RE: Drainage Channel Calculations for Western States Minerals Corporation, J. B. King Mine, INA/015/002, File #3, Emery County, Utah

Synopsis of Correspondence

Recommendations

Typical channel dimensions

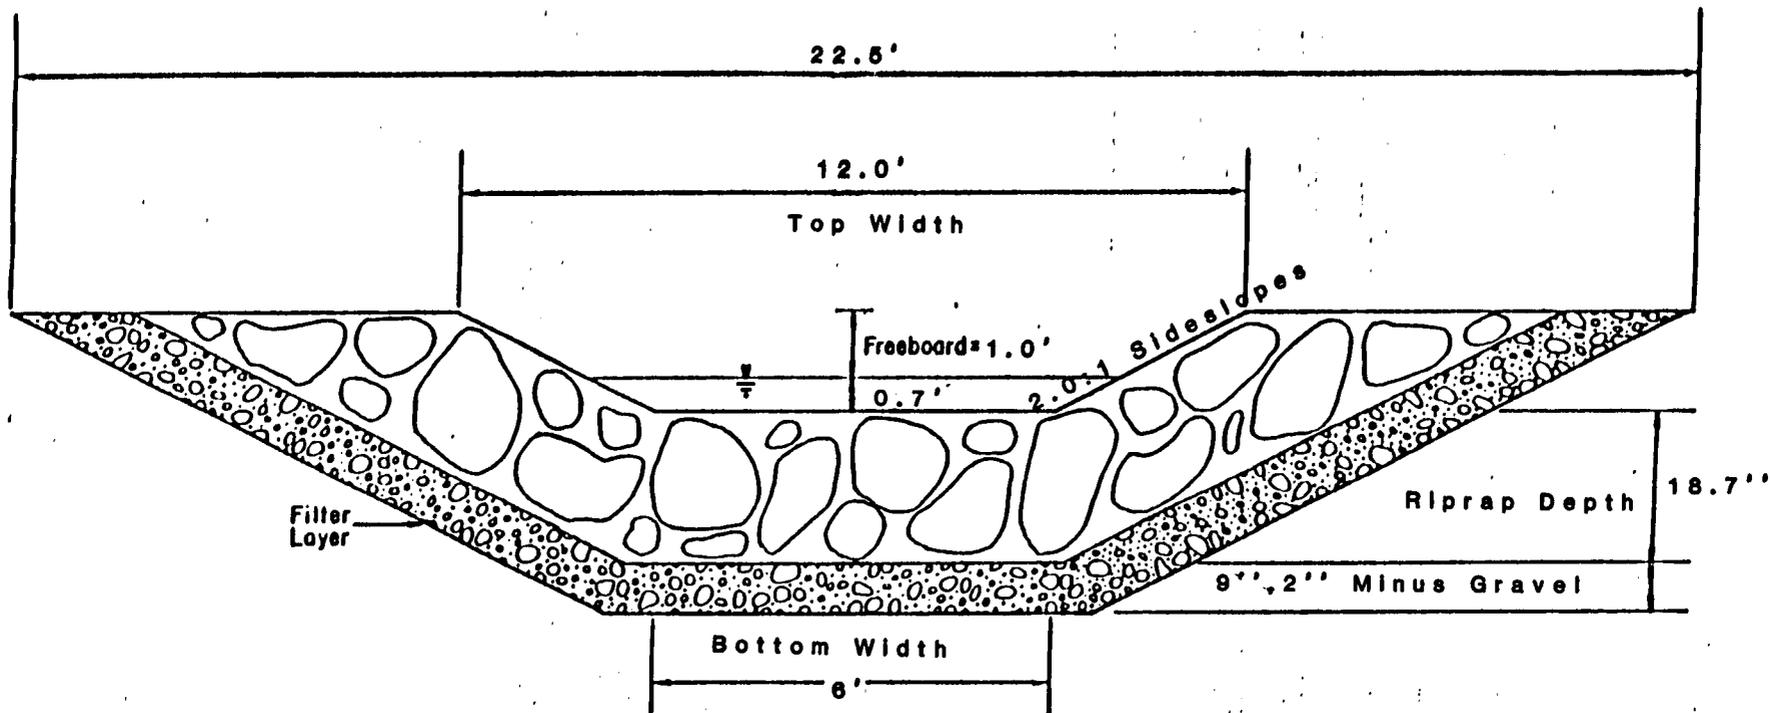
An intercept ditch is needed at the base of the highwall to route flows to the main ephemeral channel from the drainage area above the portal bench area to prevent erosion in area between the refuse pile and the ephemeral channel. A triangular channel is suggested, with 2.0:1 sideslopes and 2.0 feet deep. Riprap gradation for this channel is as follows.

D100	8"
D 85	6.5"
D 50	4.0"
D 20	2.0"
D 10	1.3"

This channel would run from the end of the refuse pile to its interception with the main ephemeral channel at a 3 percent slope towards the main ephemeral channel (see attached map). The entire 2.0 foot channel depth will be riprapped. A 9-inch deep, 2-inch minus gravel filter blanket shall be placed under the graded riprap. The depth of the riprap will be 8 inches deep. The channel depth will be in addition to the depth of the riprap or the filter blanket. If a trapezoidal channel configuration is preferred, the Division would calculate the appropriate channel dimensions for the operator at his request.

Typical channel dimensions

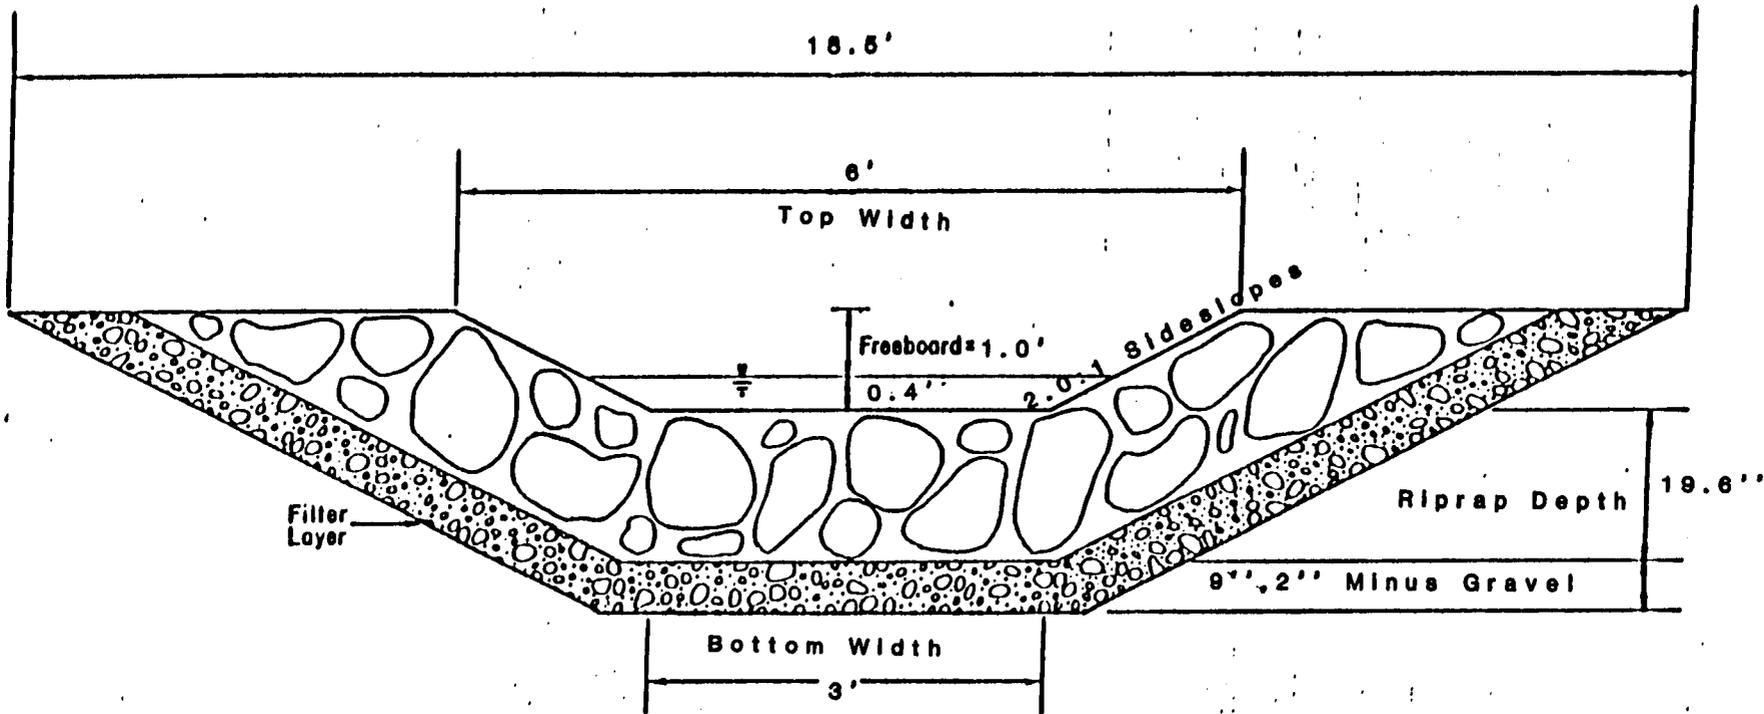
The following channel parameters are needed for the main ephemeral channel. A trapezoidal ditch with a 6-foot bottom width, 1.7 foot depth and 2:1 sideslopes would be acceptable to the Division. The riprap gradation is as follows:

D100	18.7"
D 85	16.0"
D 50	15.0"
D 20	7.5"
D 10	5.0"

A 15-foot apron at the transition zone between the steep slope section and the mild slope below station 8+00 using the same riprap gradation is necessary. The entire 1.7 foot channel depth will be riprapped and any regraded slope above the height of the

riprapped portion of the channel will be brought back to a 3.0:1 sideslope or less to prevent erosion. A 9-inch deep, 2-inch minus gravel filter blanket will be placed under the graded riprap. The depth of the riprap will be 1.7 feet deep. The channel depth will be in addition to the depth of the riprap or the filter blanket.

Typical channel dimensions
 for feeder ditch

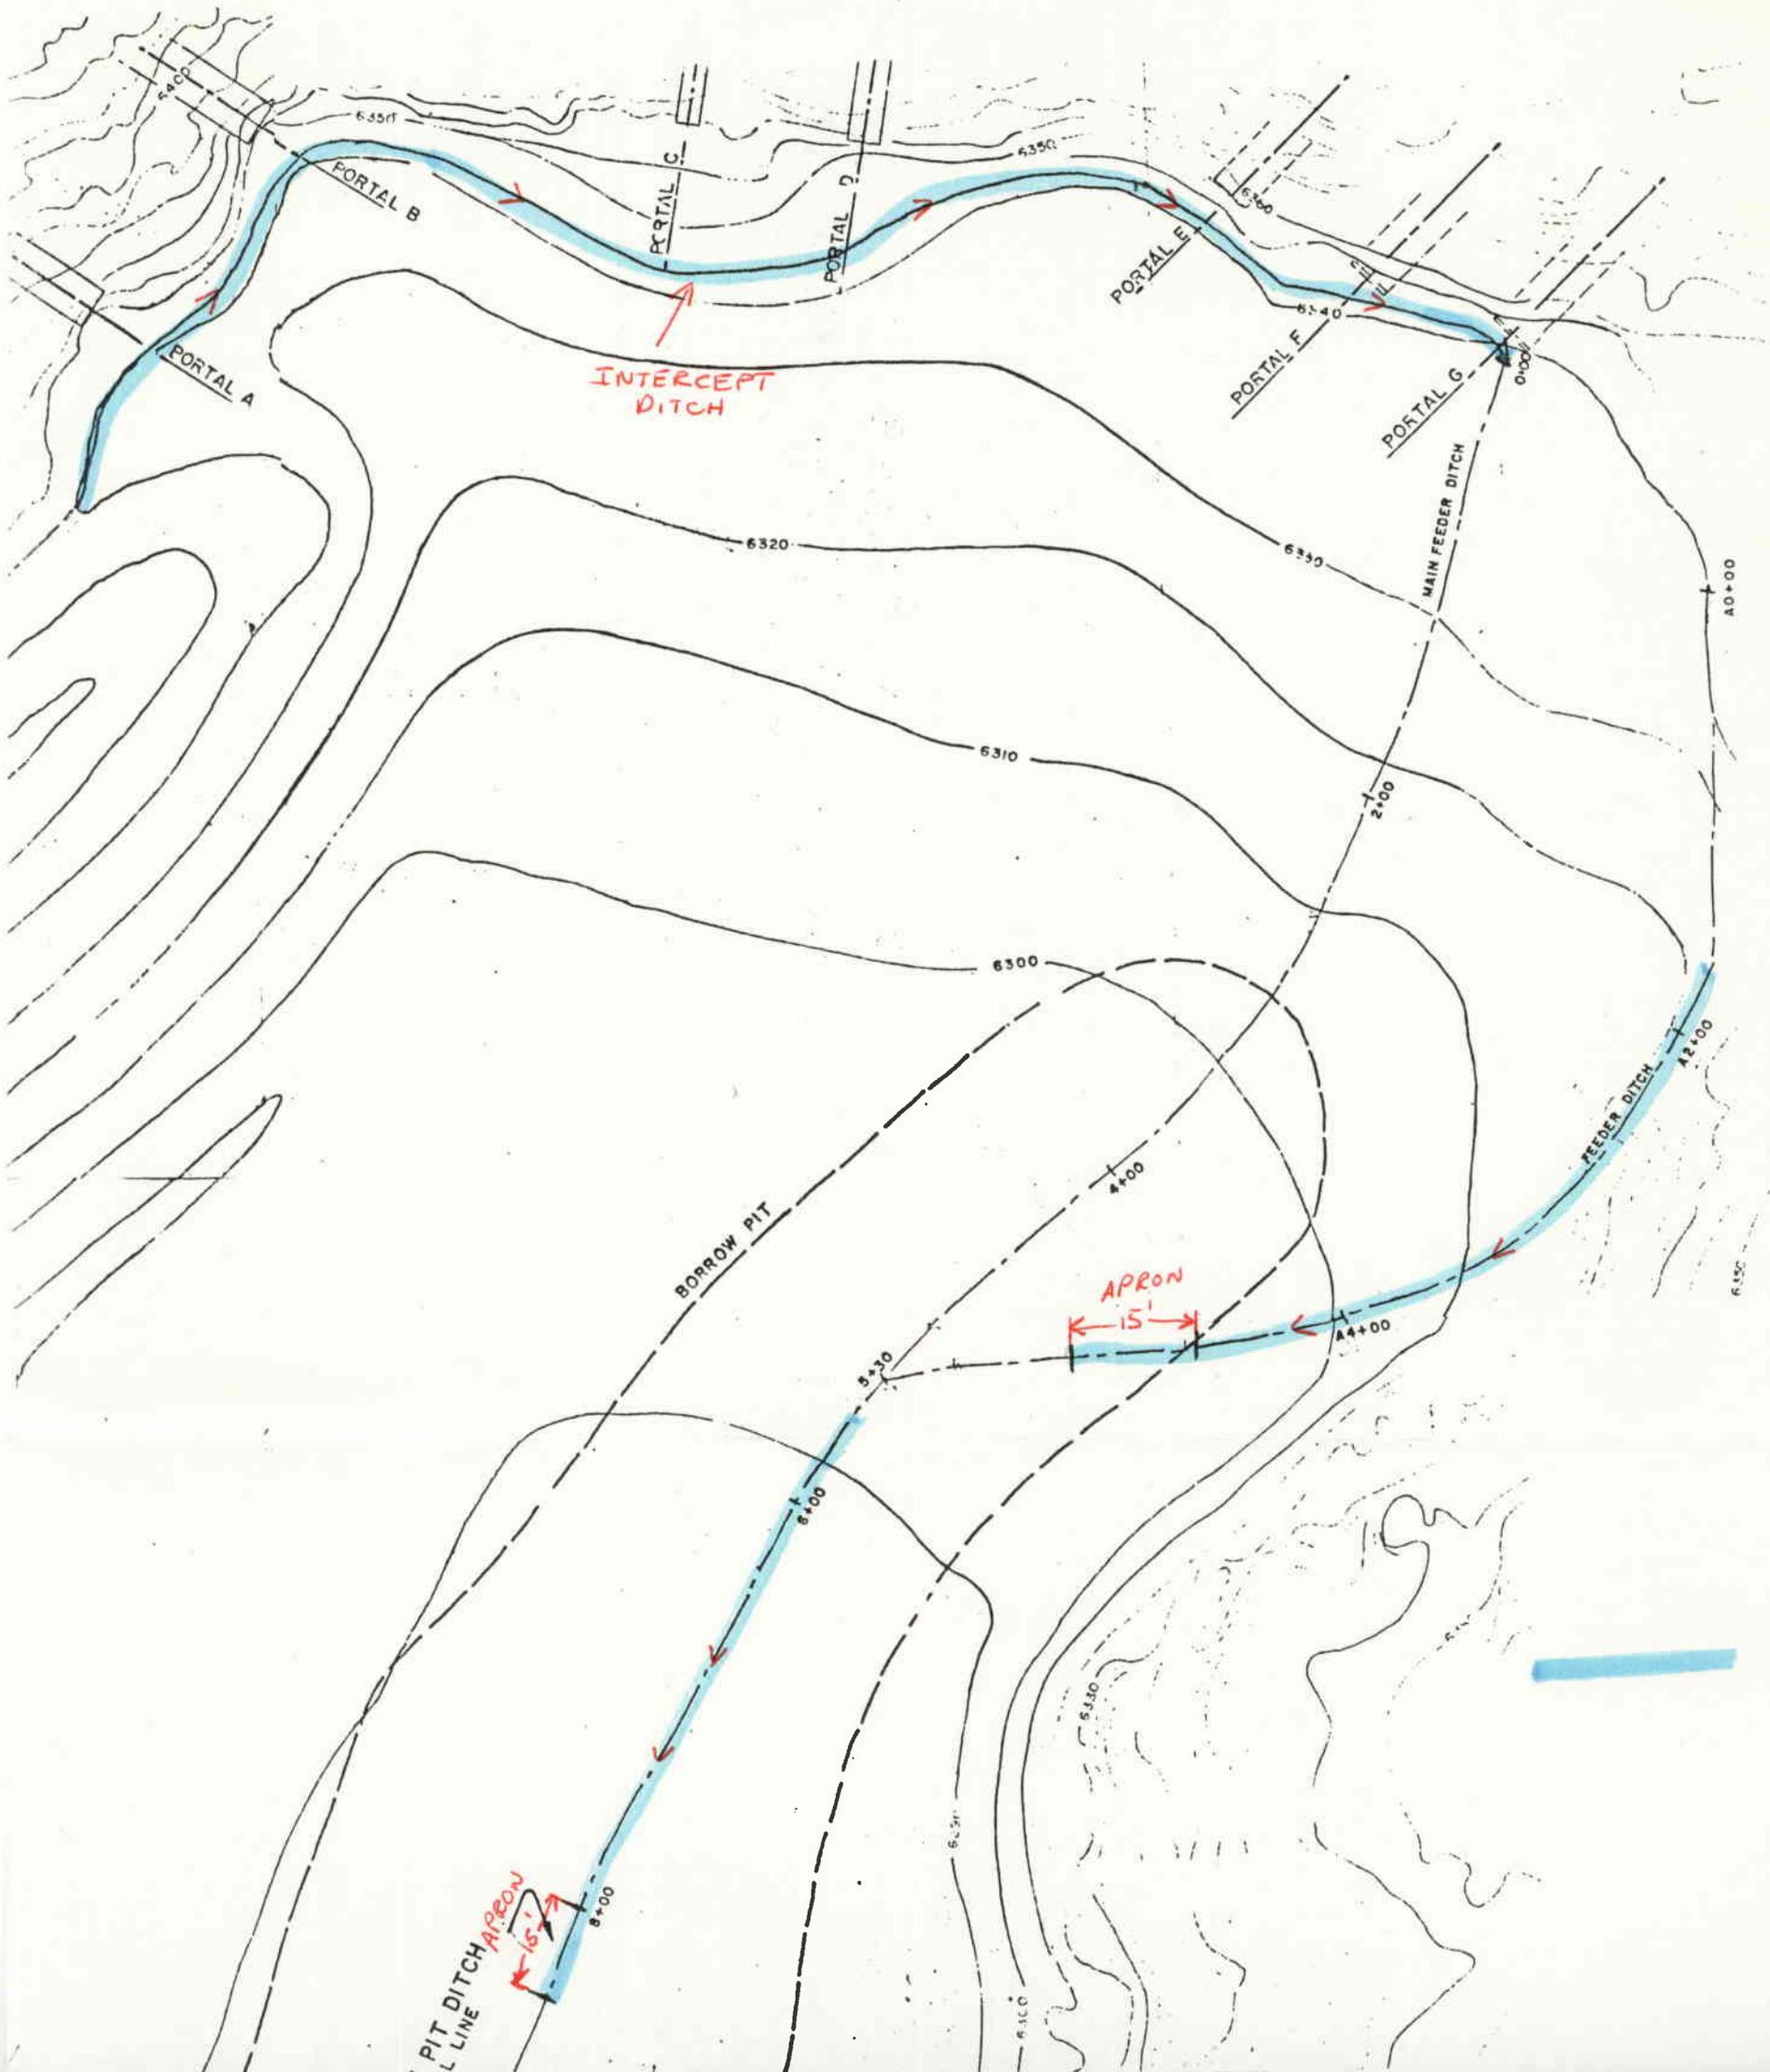
The following channel parameters for the feeder ditch channel are required. The channel will consist of a trapezoidal ditch with a 3-foot bottom width, 1.4 foot depth, and 2.0:1 sideslopes. The riprap gradation is as follows:

D100	19.6"
D 85	18.0"
D 50	15.6"
D 20	7.8"
D 10	5.1"

A 15-foot apron at the transition zone between the steep slope section and the mild slope at the base of the feeder ditch using the same riprap gradation is needed. The entire 1.4 foot channel depth shall be riprapped and any slope above the height of the riprapped portion of the channel will be brought back to a 3.0:1 sideslope or less. A 9-inch deep, 2-inch minus gravel filter blanket will be placed under the graded riprap. The depth of the riprap will be 1.63 feet deep. The channel depth will be in addition to the depth of the riprap or the filter blanket. Extra care will be taken placing riprap where the bedrock outcrops to insure stability of the channel downstream of this point.
